February 22, 2021

Re: Comments of Horizon West Transmission, LLC on the Draft Environmental Impact Report for the Estrella Substation and Paso Robles Area Reinforcement Project, December 2020 (California State Clearinghouse No. 2018072071)

Figure 2. Preliminary Plan

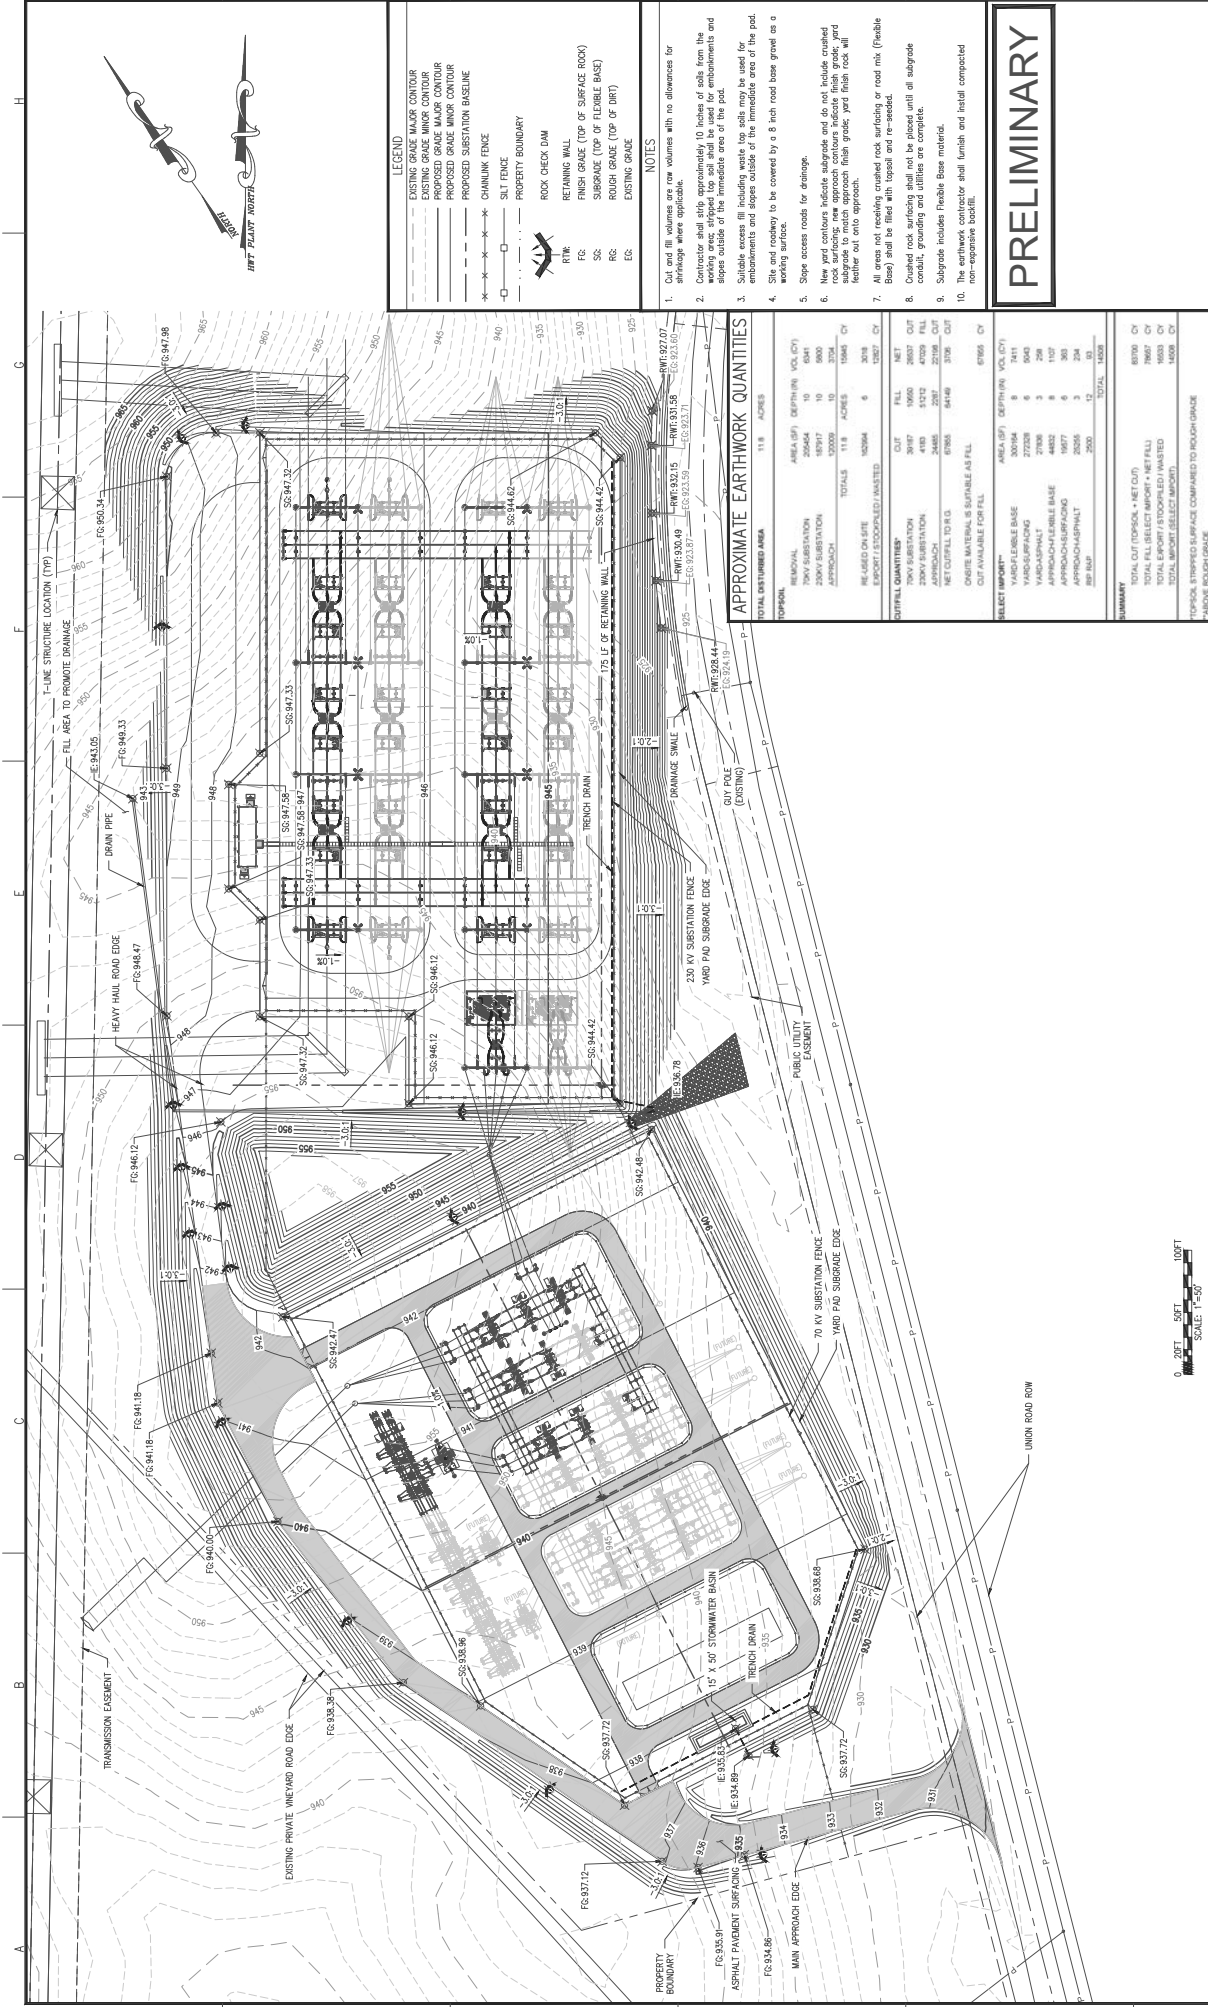
At its closest point, the fence line will be located approximately 64 feet northwest of Union Road, as shown in Figure 2 in **Attachment 1** hereto. Without this change, the design would preclude access to the five-acre addition to the site. This slight reorientation will require approximately 72,000 cubic yards of cut and fill, which will be balanced on site to the extent feasible. The MPR will only result in a slight reconfiguration of the yard equipment and will not affect the type of electrical equipment to be housed within the site’s fence line as originally proposed.

The MPR would slightly reorient the 230 kilovolt (kV) and 70 kV yards and associated equipment closer to Union Road to allow access to the additional five acres of land in the northeast portion of the parcel. At its closest point, the fence line for the 230 kV and 70 kV yards would be located approximately 64 feet northwest of Union Road. The configuration of the electrical equipment for the 230 kV and 70 kV substations is provided in Figure 2. The slight reorientation of the substation facilities would require approximately 68,000 cubic yards of cut and fill, which would be balanced on site to the extent feasible. The MPR would extend construction activities at the substation site by one week. The MPR would only result in a sight reconfiguration of the yard equipment and would not affect the type of electrical equipment to be housed within the substation fence line, as originally proposed.

Figure 2-1

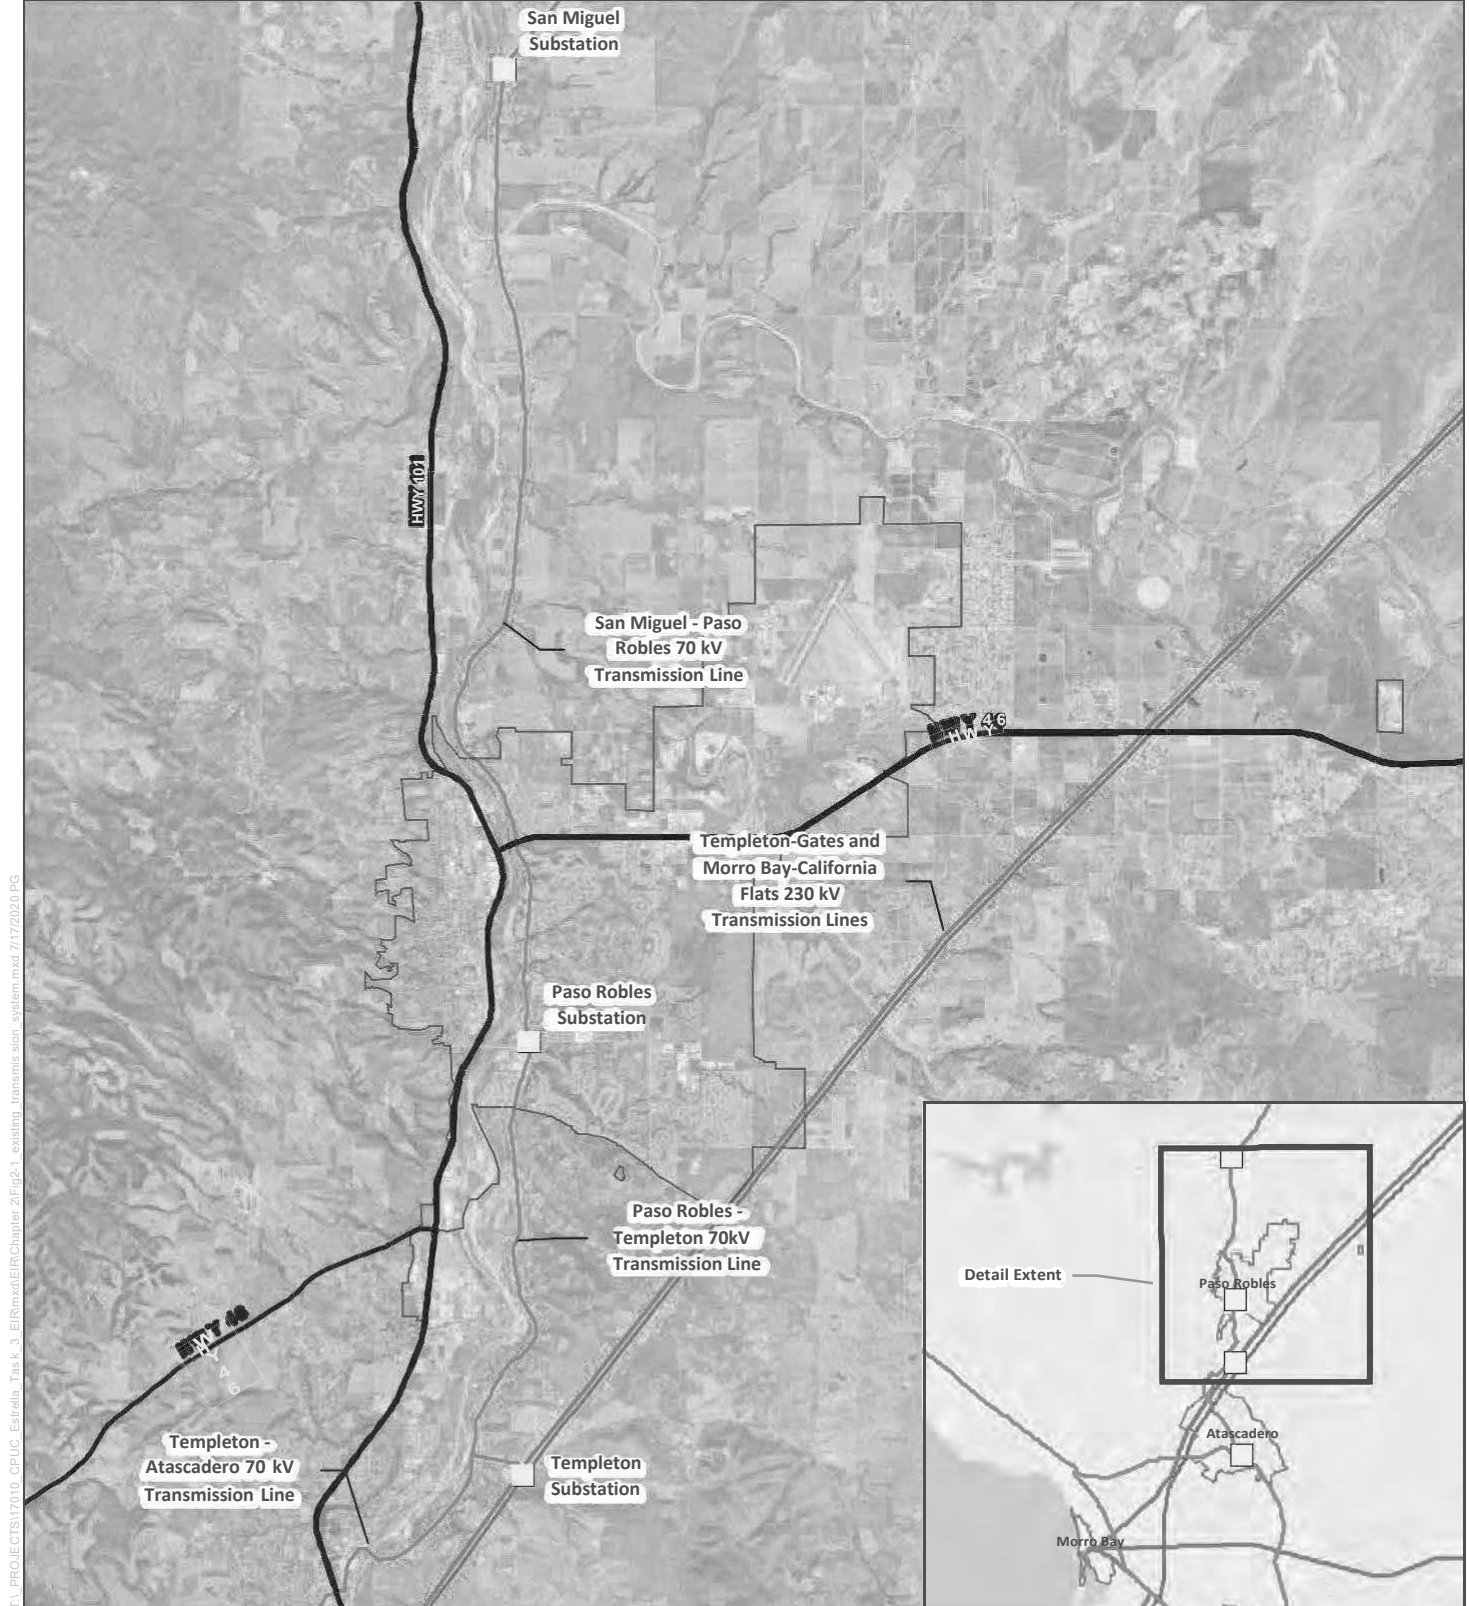
| Page # | DEIR Language | Horizon West Transmission Comments |
|--|--|--|
| 2-4 | Figure 2-1 | The 500kV line is north of the 230 kV line, not south as currently depicted in the figure. |

Figure 2-4
Existing Distribution System

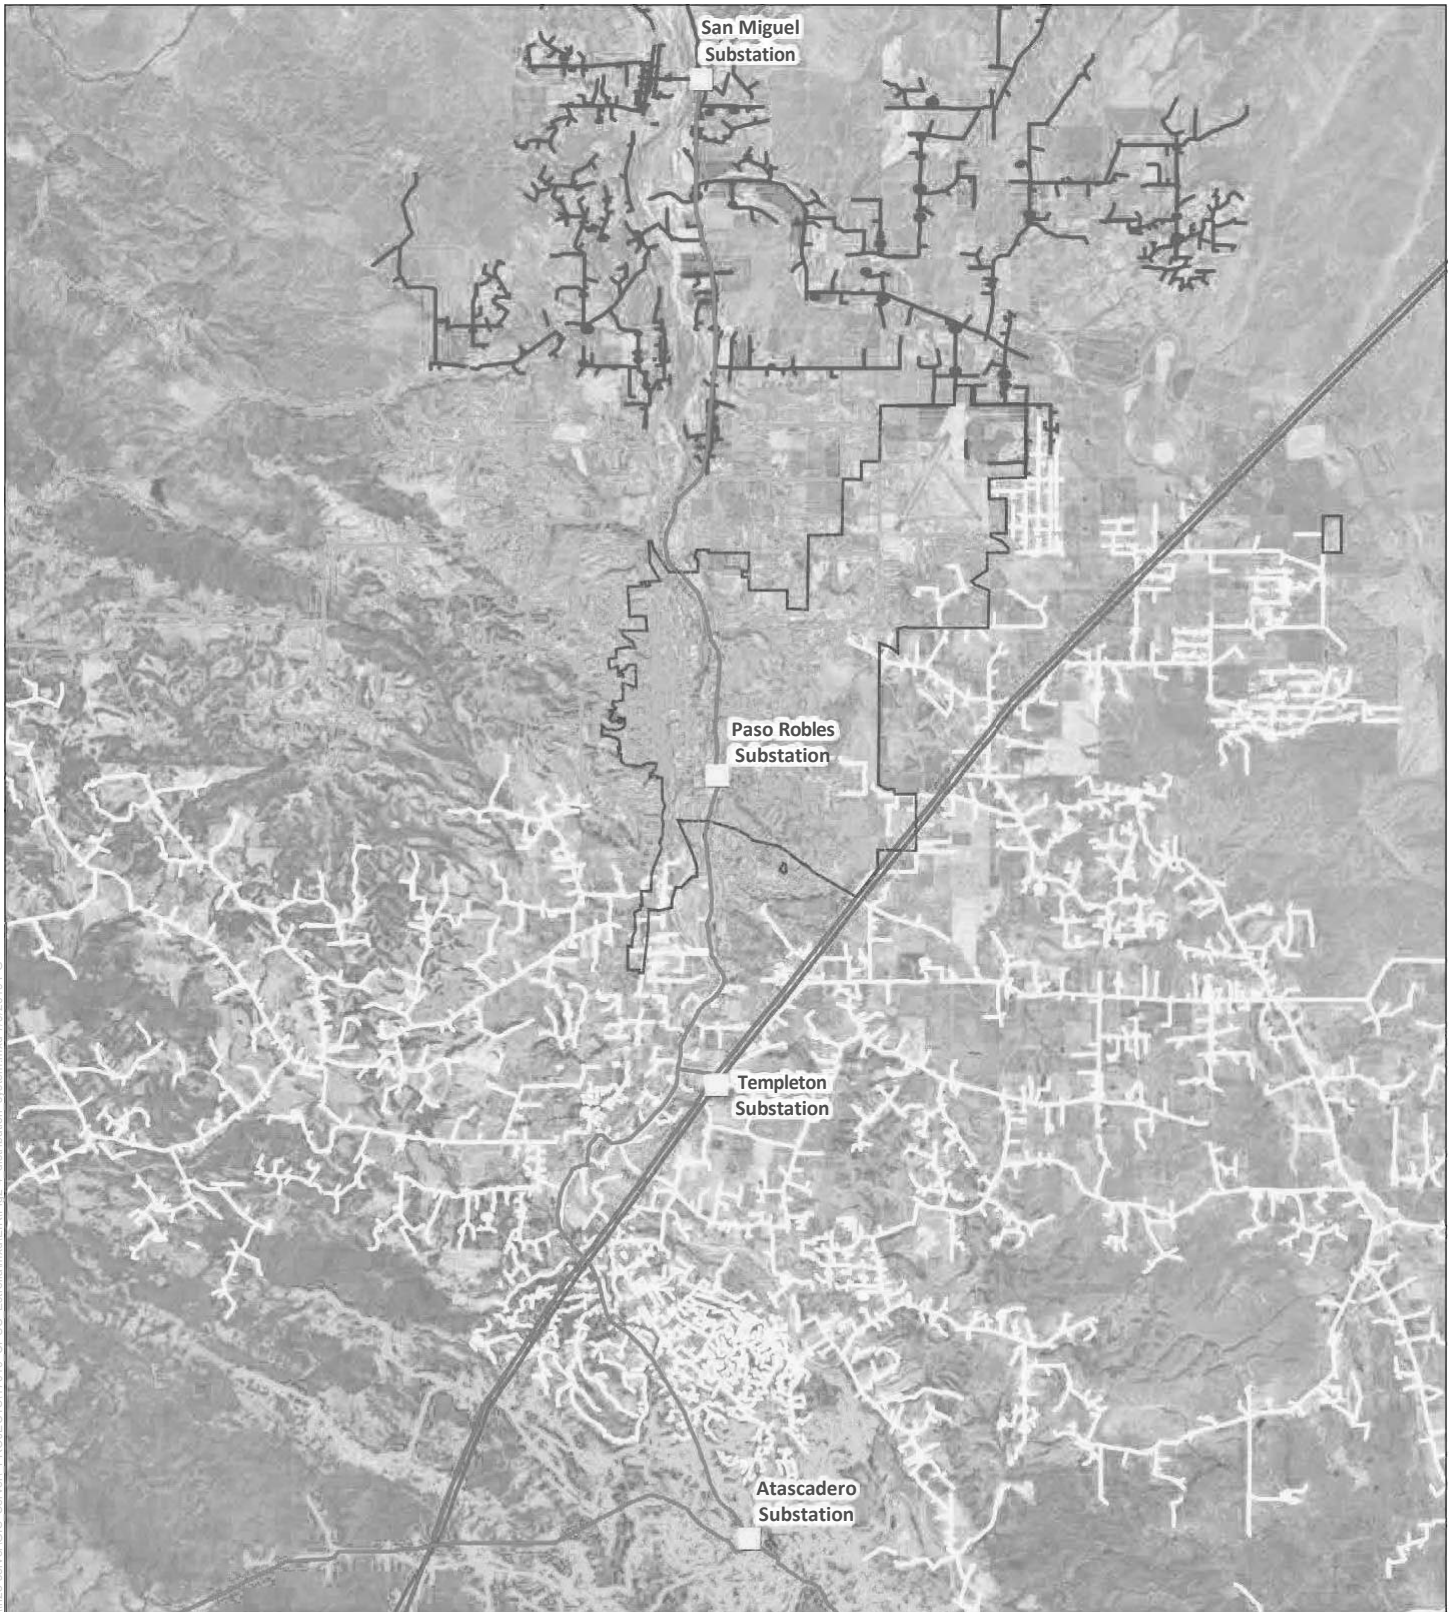
| Page # | DEIR Language | Horizon West Transmission Comments |
|--|--|--|
| 2-7 | Figure 2-4 | The 500kV line is north of the 230 kV line, not south as currently depicted in the figure. |

Figure 2-7

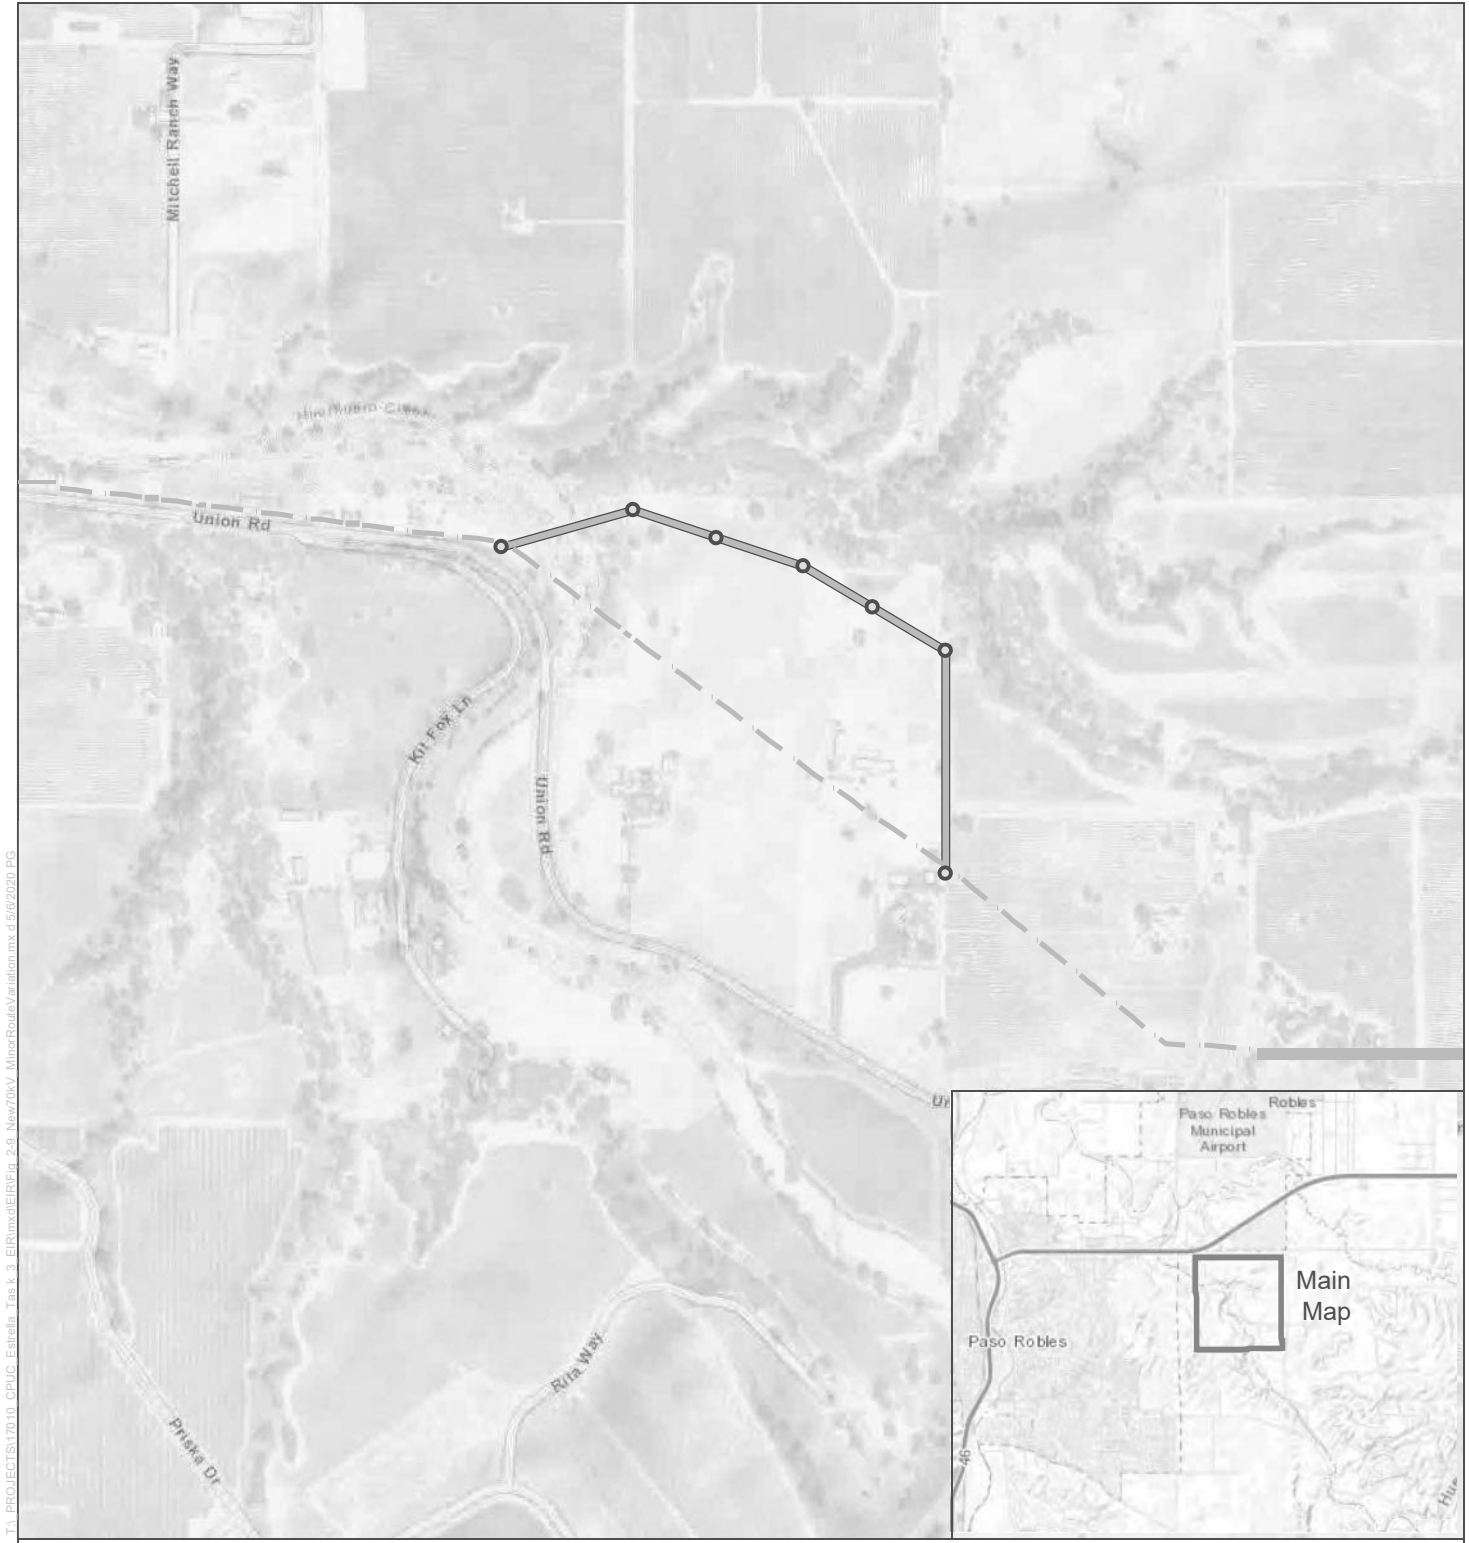
| Page # | DEIR Language | Horizon West Transmission Comments |
|--------|--|--|
| 2-22 | Figure 2-7 | Replace figure to include new substation parcel and update temporary and permanent disturbance areas |
